KARACHI MUNICIPALITY.

Order under Section 96 (2) of Act III of 1901.Mr. Jannadas Vishindas

PLAN SHOWING THE PROPOSED GODOWNS ON PLOT

NO. 70, N.P. 5, NAPIER Q.R.

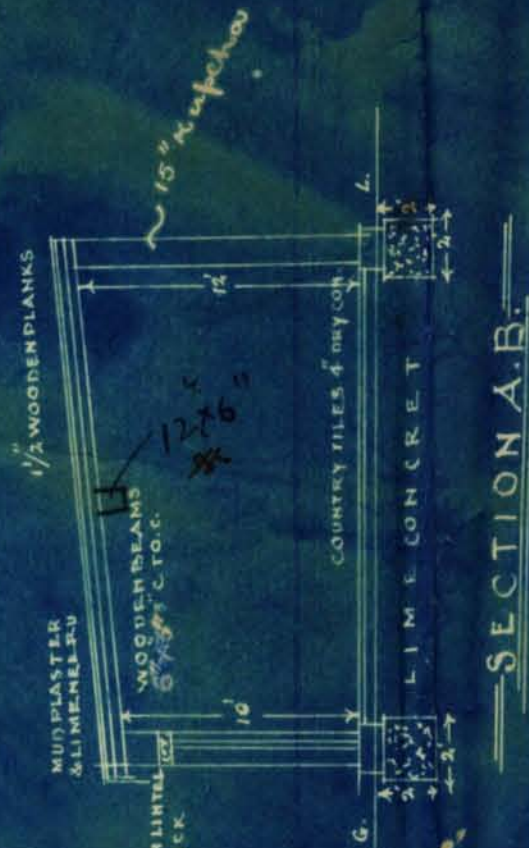
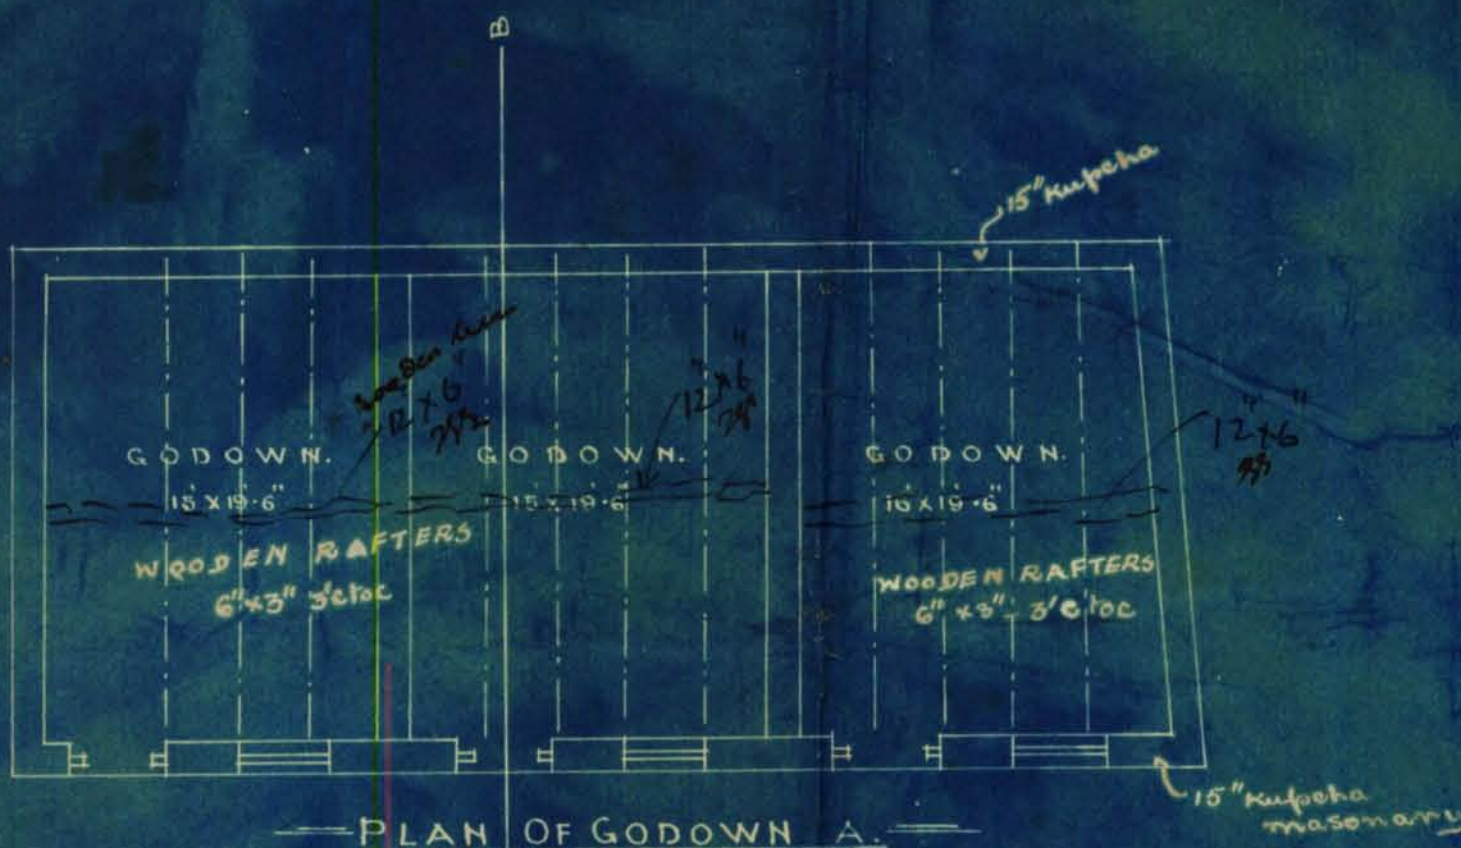
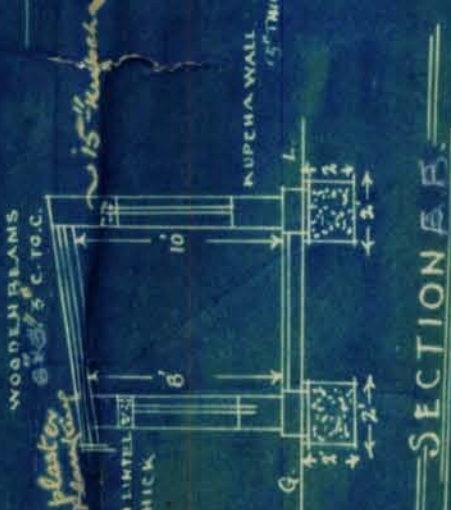
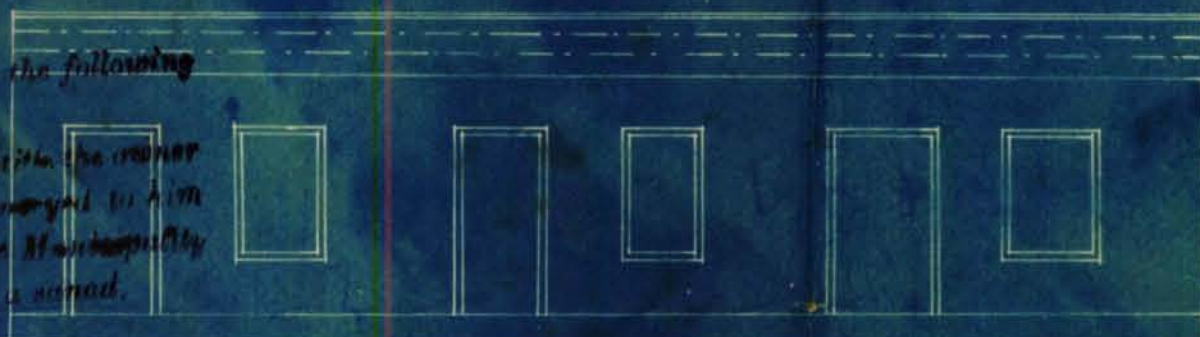
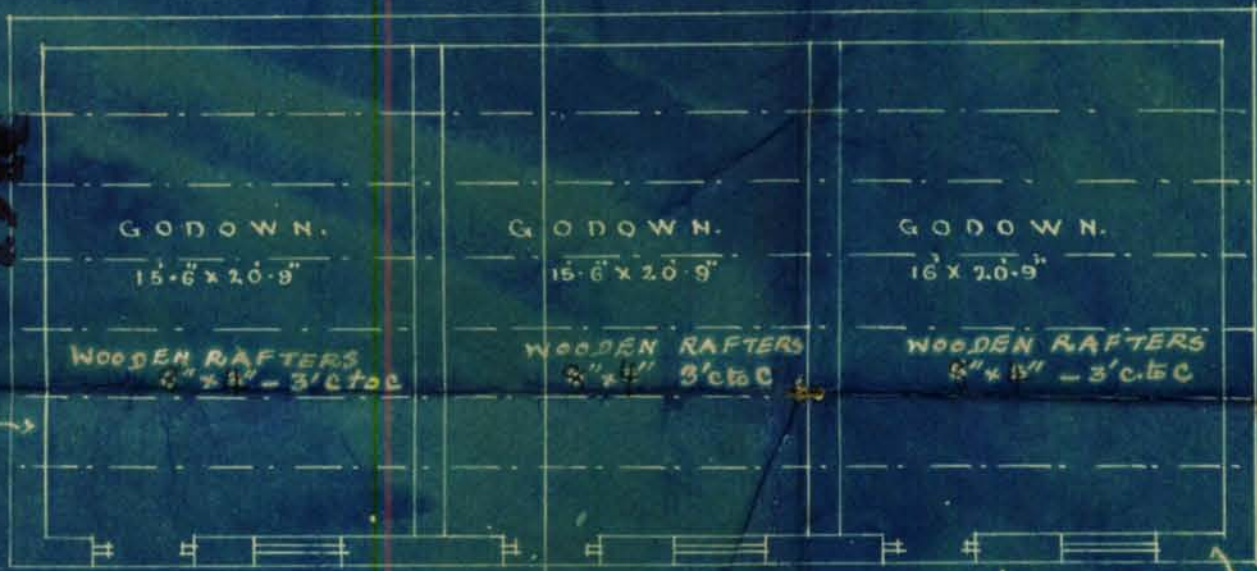
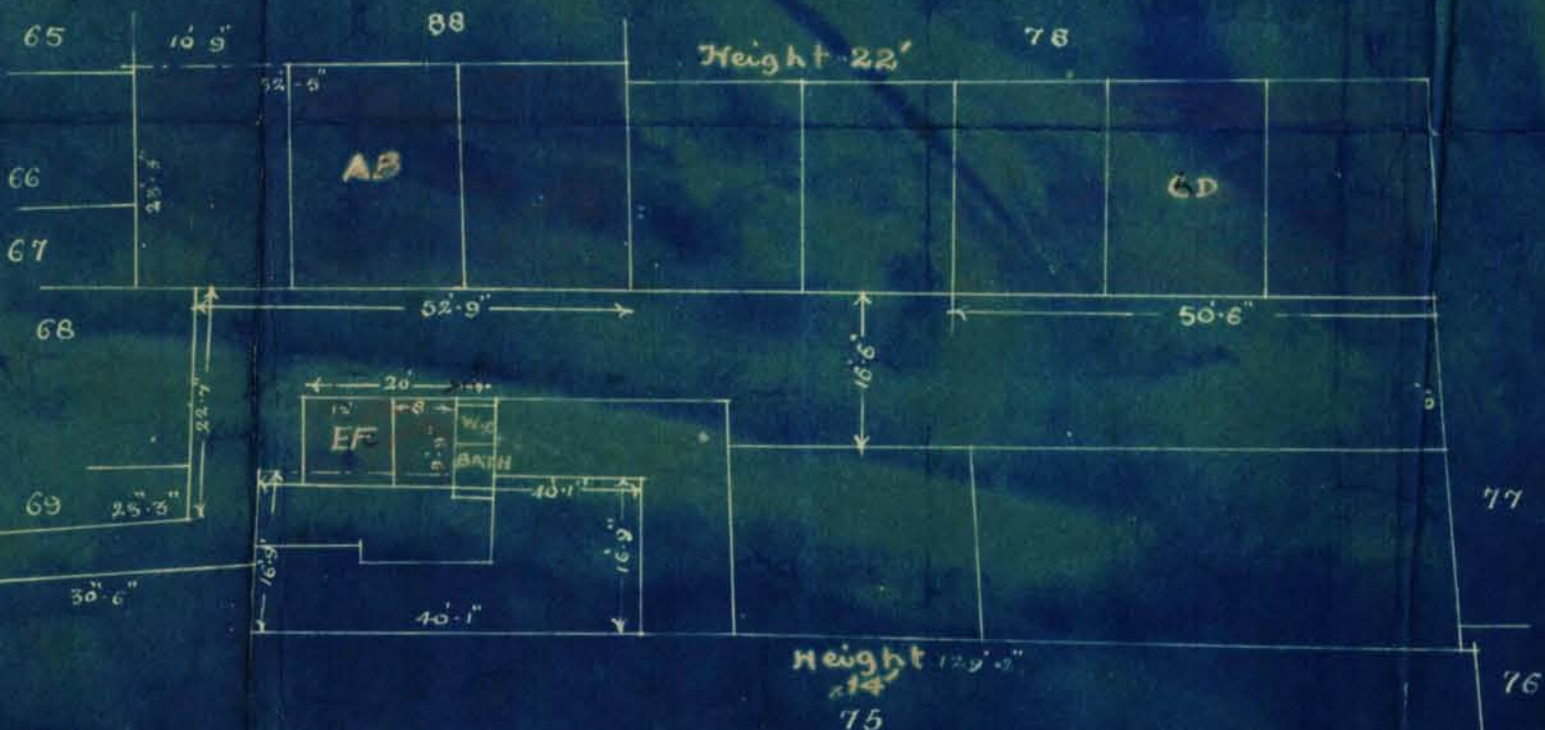
- (1) materials and quality of all masonry must be specified
- (2) It is not understood as to why all section lines are marked "AB" and thus confusion is created. Different letters must be used.
- (3) The height of the proposed plinth must be dimensioned.
- (4) Thickness of all the walls must be given.
- (5) Size of all roof members must be written down on plan and in section as well.
- (6) Site plan is very ambiguous and incomplete. It cannot be understood from it as to what is existing and what is proposed to be constructed. All the proposed additions must be verged vermillion red.
- (7) Heights of buildings on the adjoining plots must also be put down.
- (8) One common W.C and bath be provided.
- (9)
- (10)
- (11)
- (12)

1) Site plan is very ambiguous and incomplete. It cannot be understood from it as to what is existing and what is proposed to be constructed. All the proposed additions must be marked vermilion red.

2) Heights of buildings in the adjoining plots must also be put down.

- 1) Materials and quality of all masonry must be specified.
- 2) It is not understood as to why all section lines are marked "AB" and thus confusion is created. Different letters must be used.
- 3) The height of the proposed plinth must be dimensioned.
- 4) Thickness of all the walls must be given.
- 5) Sizes of all roof members must be written down on plan and in section as well.

Submitted
Proposed revision for
Gordon "AB" are made.
Quote "therefore a further
must be proposed. Proposed
Gordon "EF" must be deleted
so the construction becomes
simplified.
Other requirements complied
with. 2/9

PLAN SHOWING THE PROPOSED GODOWNS ON PLOT

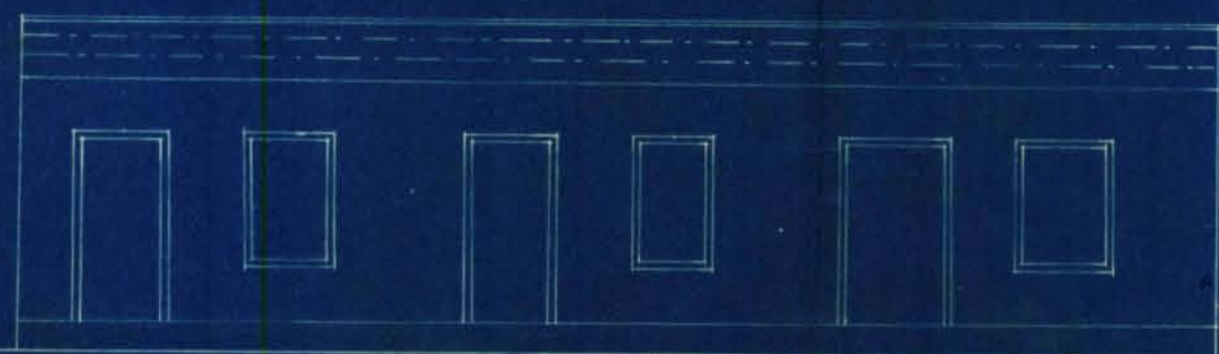
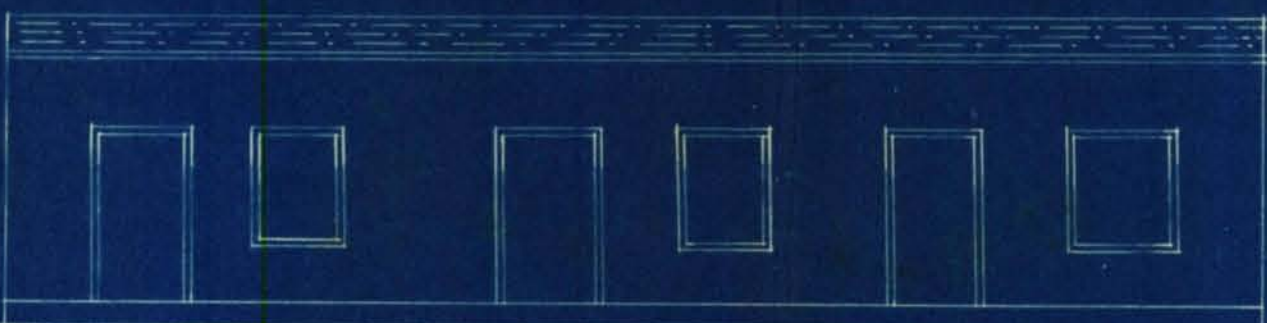
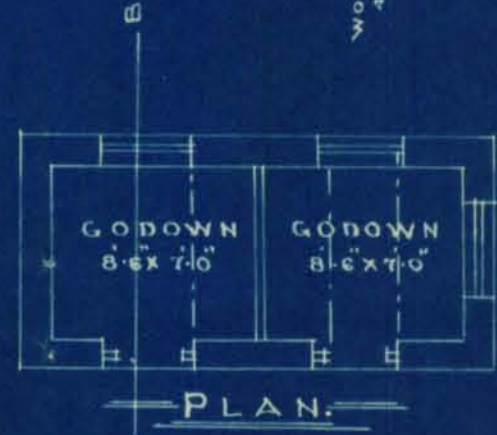
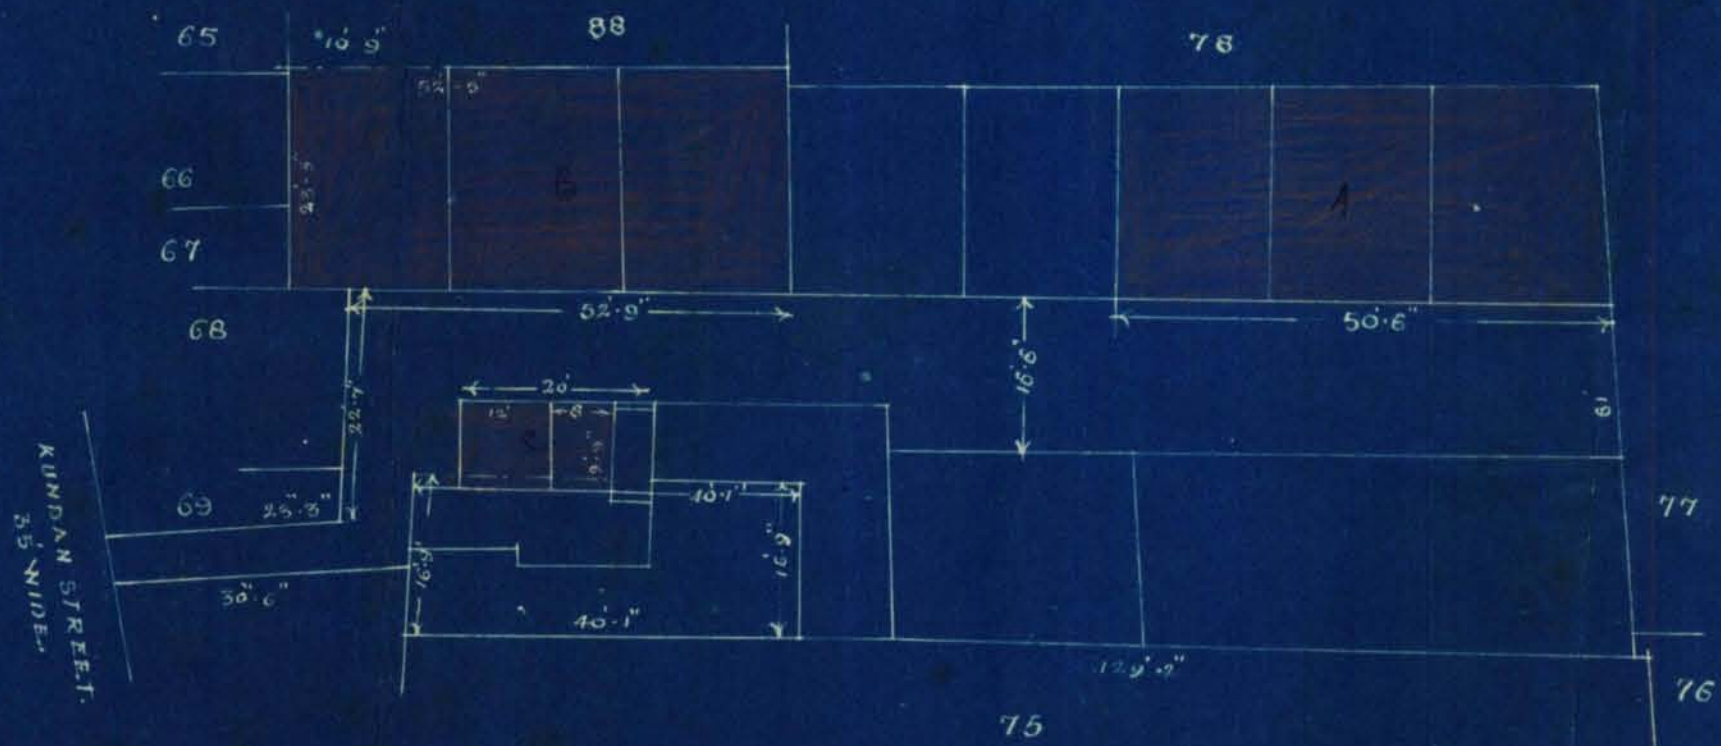
- 1) For 19' 6" Span 8" x 6" beams are inadequate. Their size be increased or a cross girder be proposed.
- 2) Nature and thickness of ~~the~~ walls be specified.
- 3) 8" x 6" beams for 15' 6" Span in godown "B" are inadequate. Their size be increased.

SITE PLAN.

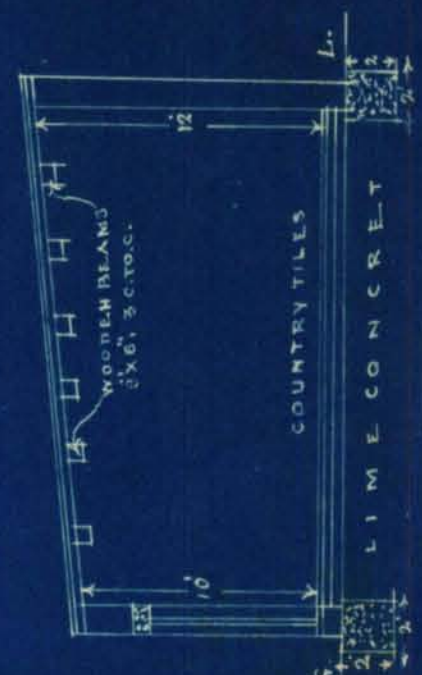
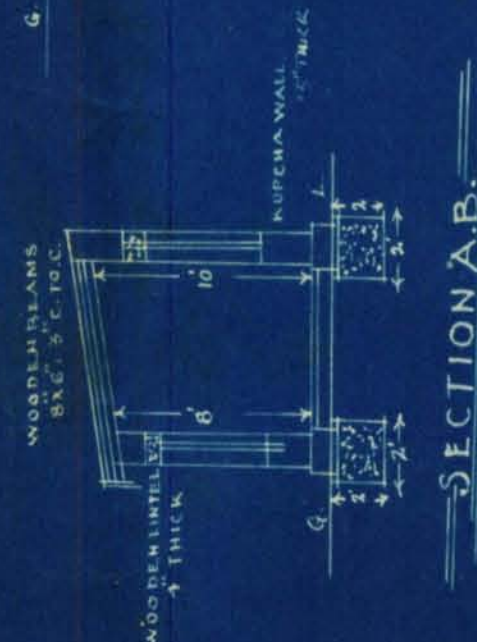
The Passage is 42" at Road end &
45" at the inside of the plot end.
